Re: National Museum of Nuclear Science & History
601 Eubank Blvd. SE
Traffic Circulation Layout
Engineer's/Architect's Stamp XX-XX-XX (L20-D065)

Based upon the information provided in your submittal received 04-10-23, the above referenced plan cannot be approved for Building Permit until the following comments are addressed:

DRAINAGE AND TRANSPORTATION INFORMATION SHEET

DRB Project Number: 2023-008328
601 Eubank SE

1 SITE PLAN
A-1.0 SCALE: 1" = 40'-0" NORTH

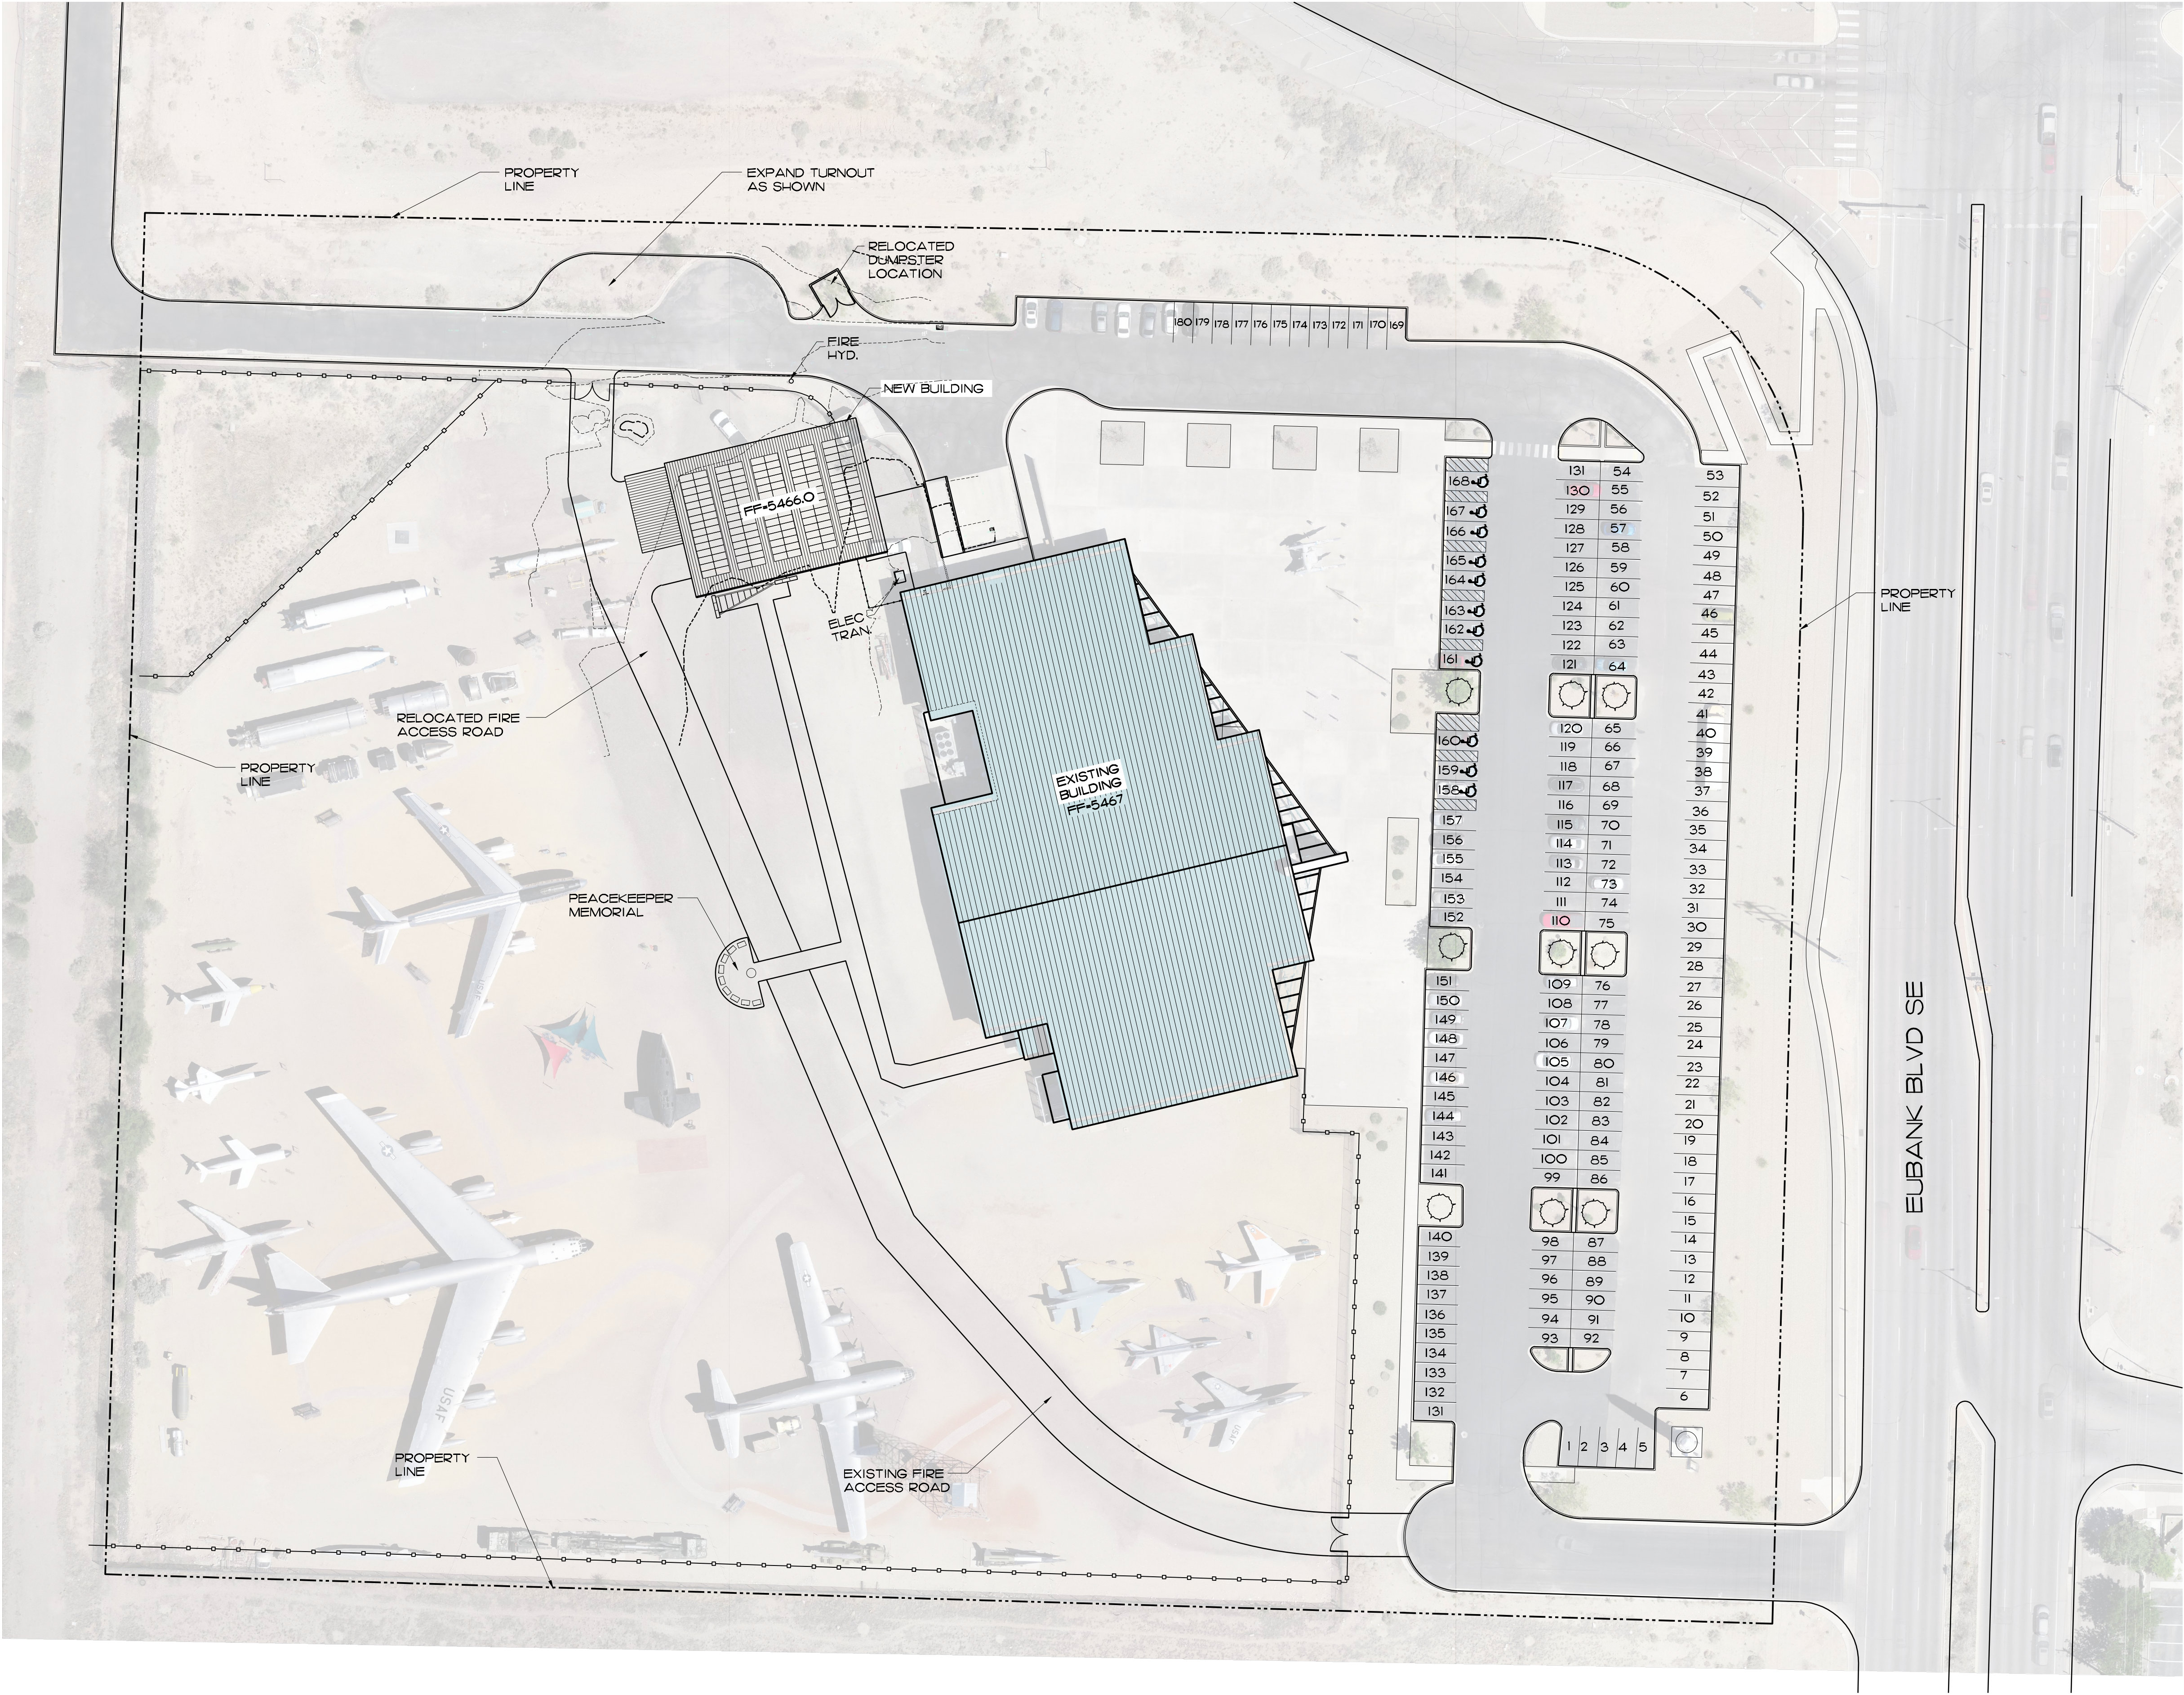
1. Please show a vicinity map showing the location of the development in relation to streets and well-known landmarks.
2. List the number of parking spaces required by the IDO as well as the proposed number of parking spaces including bicycle and motorcycle parking.
3. The traffic circulation layout must be stamped, signed, and dated by an engineer or architect licensed in the state of New Mexico.
4. Identify all existing access easements and rights of way width dimensions.
5. Identify the right of way width, medians, curb cuts, and street widths on Eubank Blvd. SE.
6. Please show on the site the width for the existing site access and drive aisles.
7. Please list the width and length for all existing and proposed parking spaces. Some dimensions are not shown.
8. The minimum parking stall dimensions are:

9. The ADA accessible parking sign must have the required language per 66-7-352.4C NMSA 1978 **"Violators Are Subject to a Fine and/or Towing."** Please call out detail and location of signs.

10. ADA curb ramp at the corner of Eubank and Southern must be updated to current standards and have truncated domes installed.

11. Please finish the construction of this ADA pathway.

12. Motorcycle parking spaces shall be designated by its own conspicuously posted upright sign, either free-standing or wall mounted per the zoning code.

13. The pavement marking "MC" should be shown in the opposite direction for motorcycles entering the parking space.
14. All bicycle racks shall be designed according to the following guidelines:

15. Bicycle racks shall be sturdy and anchored to a concrete pad.
16. A 1-foot clear zone around the bicycle parking stall shall be provided.
17. Bicycle parking spaces shall be at least 6 feet long and 2 feet wide.

18. List radii for all curves shown; for passenger vehicles. Radius for delivery trucks, fire trucks, etc. is 25 ft. or larger.
19. Refuse vehicle maneuvering shall be contained on-site. The refuse vehicle shall not back into the public right of way.; provide a copy of refuse approval.

21. It is not apparent what type of pavement surface is being proposed. A hard driving surface will be required as part of this proposed project for parking area and drive aisles.

22. Show the clear sight triangle and add the following note to the plan: "Landscaping and signage will not interfere with clear sight requirements. Therefore, signs, walls, trees, and shrubbery between 3 and 8 feet tall (as measured from the gutter pan) will not be acceptable in the clear sight triangle.

1. As this plan is modifying the fire access and dumpster location, this will require an approved Traffic Circulation Layout (TCL) prior to site plan. Please also obtain Fire Marshall and Solid Waste approval.
